Product Update

Document Number: 1TQC135500E0001, Rev A	Issue Date: 3/18/2025
Modular Metering Global Product Manager: Adam Busocker	Products Impacted: Reliamod Residential Modular Metering (See list of Materials below)
R&D Manager: Heather LeBlanc	Impact to Form/Fit/Function: Yes

The purpose of this communication is to inform you about a product change update for all ReliaMod Modular Metering Residential Stacks (125A & 225A). All 3 Phase-in residential meter stacks up to 225A will have the 5th jaw factory installed, and all 1 Phase-in stacks will have the 5th jaw orderable as a kit (RM5THJAW).

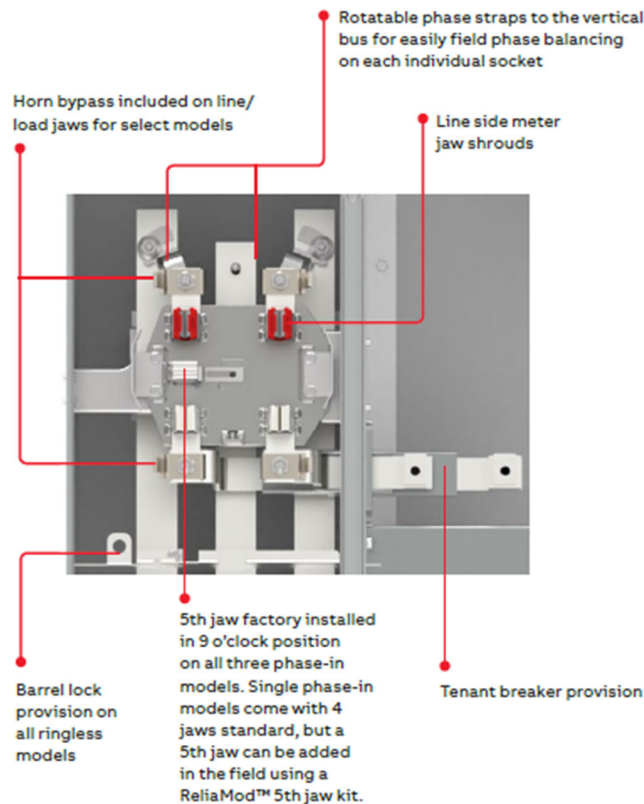
This figure from the buylog highlights the location of the 5th jaw. It is required to connect the sockets to the utility metering, for all 3 Phase in stacks.

Any orders placed on ReliaMod Modular Metering residential stacks prior to December 5th, 2024; had the 5th jaw factory installed in all Ring Type sockets, for 3 Phase-in and 1 Phase-in stacks. The 5th jaw was orderable as a kit for Ringless and Ringless w/ HBP, for 3 Phase-in and 1 Phase-in stacks.

After December 5th, the buylog, configurator, and outline drawings were all updated for the new 5th jaw alignment. As of March 5th, the bills of materials were updated, and testers at the manufacturing plant were updated, to ensure all products shipped meet the new alignment.

Any customer may return the "RM5THJAW" kit, if their stack now has 5 jaws factory installed. Any customers can purchase "RM5THJAW" kit, if their stack now has 4 jaws factory installed but they need a 5th jaw.
